# DrawDiff Comparison Report

Part number: DA1840189 | Job: d7991738-6858-49be-a585-d7e79417e8af | Generated: 2026-04-28T18:27:29+00:00

The revision of DA1840189 from TS to Rev A represents a significant drawing restructuring: the original isometric and auxiliary views (ISO\_1, ISO\_2, VIEW\_1, SIDE, VIEW\_8) have been replaced by a new view set (ISO\_FRONT, ISO\_REAR, MAIN\_TOP, SECTION A-A, SECTION B-B, ANNOTATION), which substantially changes how the part geometry is documented and must be verified for completeness. Most critically, the left isometric view in the revised drawing appears to show the top-center raised boss or protrusion as flattened or removed — a potential functional geometry change that requires immediate design authority confirmation before release. Additionally, the pocket corner radius count was halved from 16X R.030 to 8X R.030 in Section C-C, which may reflect a re-specification of applicable corners or an actual reduction in corner breaks, with direct implications for stress concentration and machining setup. Supporting changes include a terminology update from 'HELICOIL' to 'HELICAL INSERTS' for procurement neutrality and addition of a proprietary markin

MAIN\_TOP [ADDED]

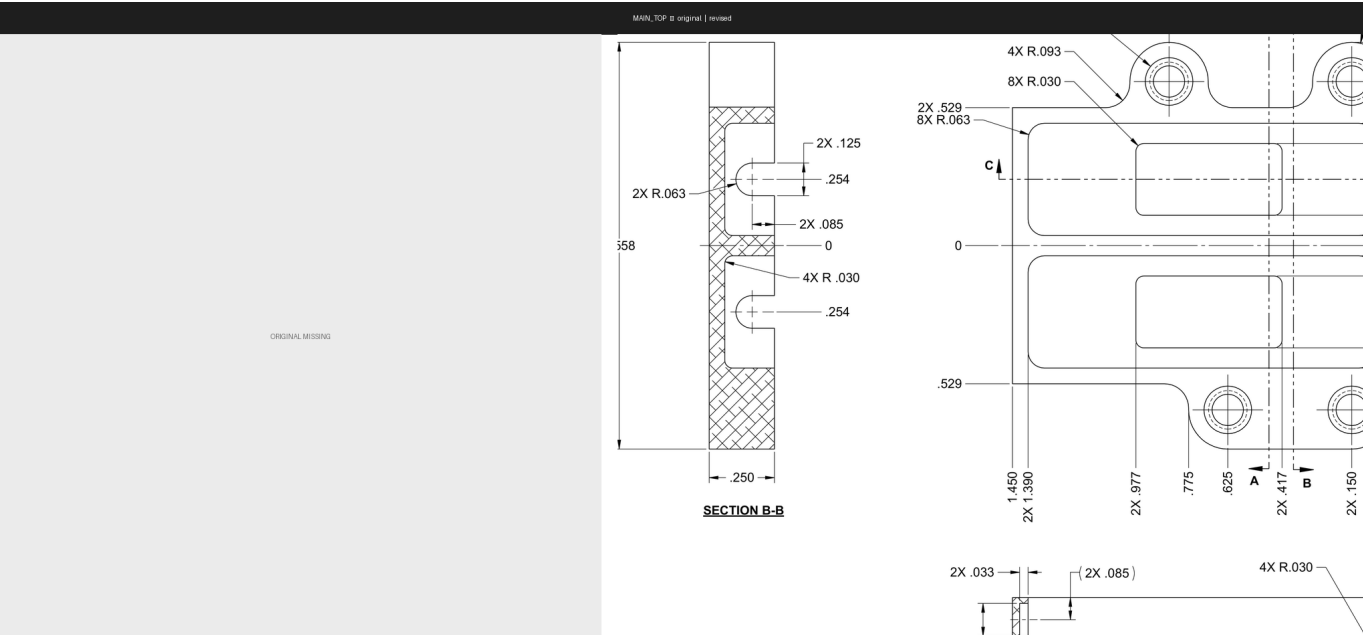
| Severity           | Field | Original | Revised  | Conf. | Rationale                                                                                                                                                                                                       |
|--------------------|-------|----------|----------|-------|-----------------------------------------------------------------------------------------------------------------------------------------------------------------------------------------------------------------|
| <b>SIGNIFICANT</b> | view  | —        | MAIN_TOP | 1.00  | View 'MAIN_TOP' appears only in the revised drawing.<br><b>Impact:</b> New top-plan view added; reviewer should confirm it establishes or supersedes any top-face dimensions previously shown in removed views. |

SECTION A-A [ADDED]

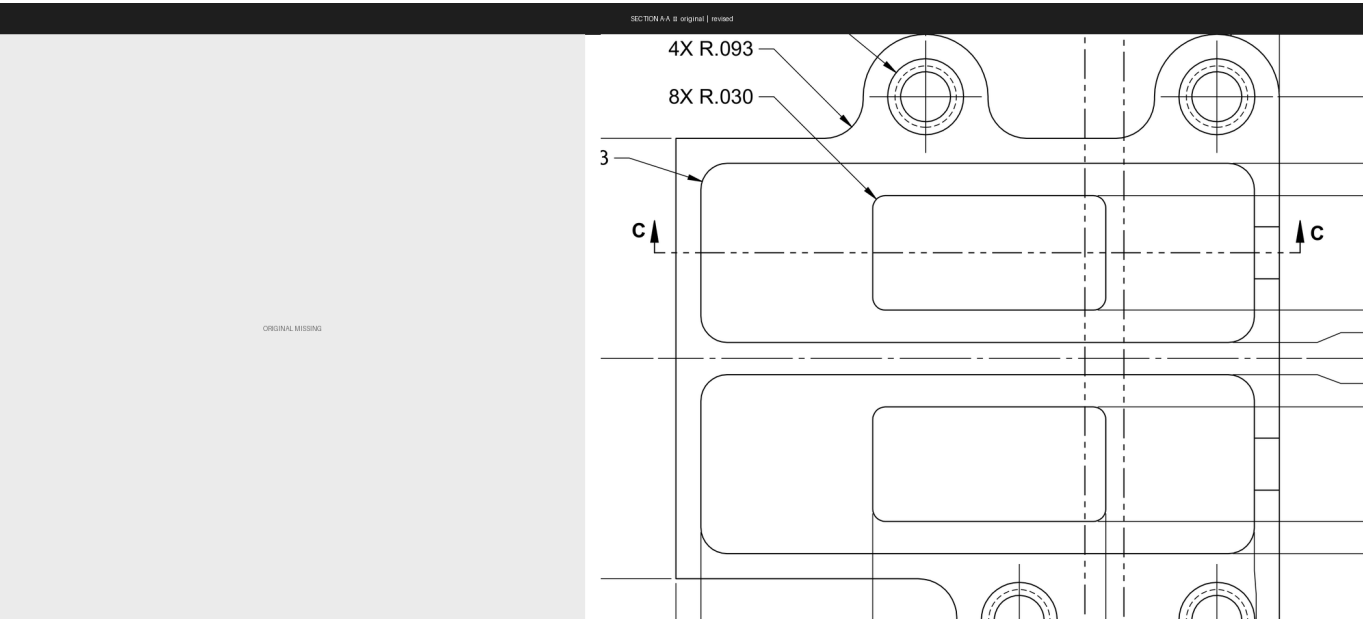
| Severity           | Field | Original | Revised | Conf. | Rationale                                               |
|--------------------|-------|----------|---------|-------|---------------------------------------------------------|
| <b>SIGNIFICANT</b> | view  | —        |         | 1.00  | View 'SECTION A-A' appears only in the revised drawing. |

| Severity | Field | Original | Revised     | Conf. | Rationale                                                                                                                                                      |
|----------|-------|----------|-------------|-------|----------------------------------------------------------------------------------------------------------------------------------------------------------------|
|          |       |          | SECTION A-A |       | <b>Impact:</b> New cross-section A-A added; must be reviewed to ensure it fully documents wall profiles and hole geometry previously covered by removed views. |

SECTION B-B [ADDED]

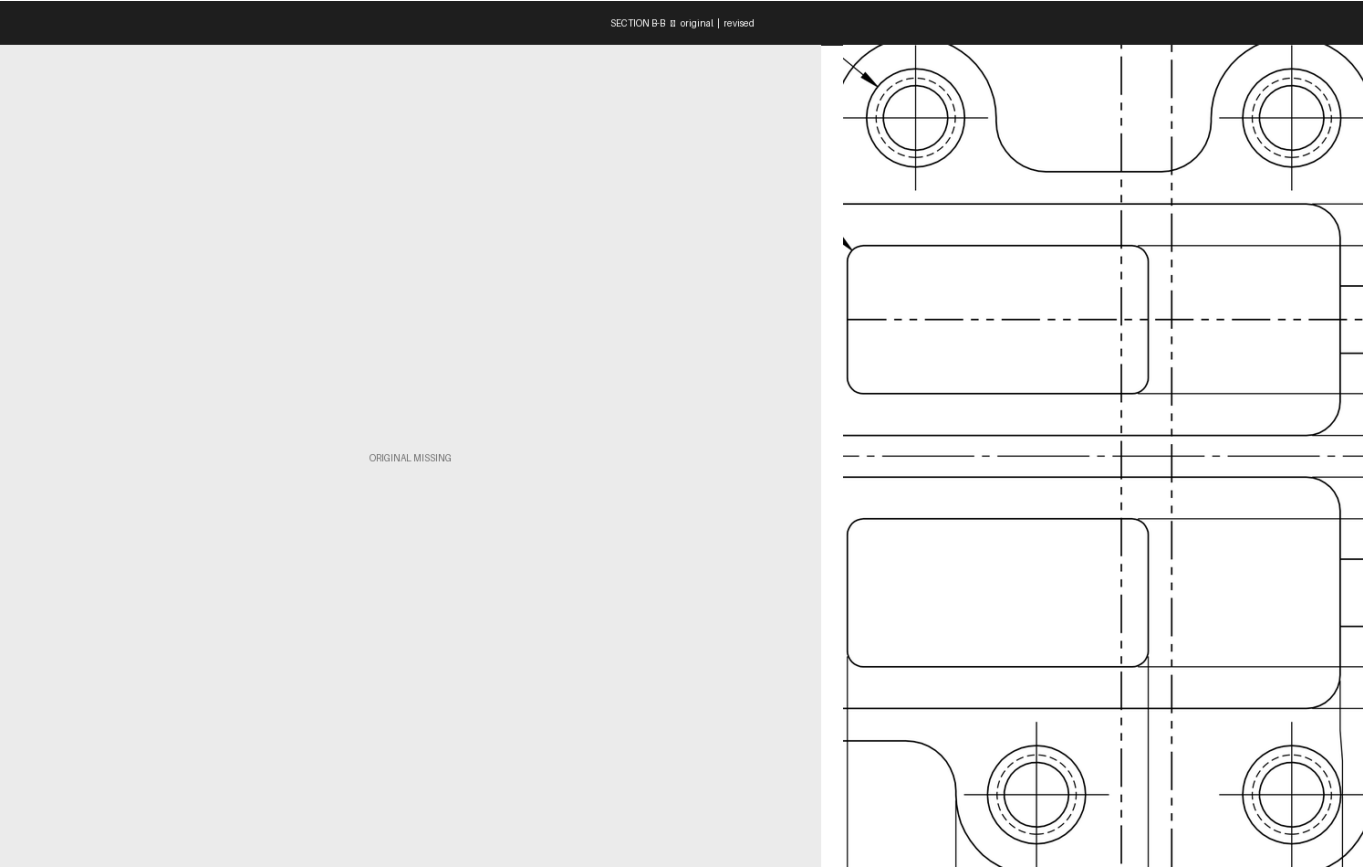
| Severity    | Field | Original | Revised     | Conf. | Rationale                                                                                                                                                                                                                 |
|-------------|-------|----------|-------------|-------|---------------------------------------------------------------------------------------------------------------------------------------------------------------------------------------------------------------------------|
| SIGNIFICANT | view  | —        | SECTION B-B | 1.00  | View 'SECTION B-B' appears only in the revised drawing. <b>Impact:</b> New cross-section B-B added; reviewer should verify it captures any slot or pocket depth information that was in the removed SIDE or VIEW_8 views. |
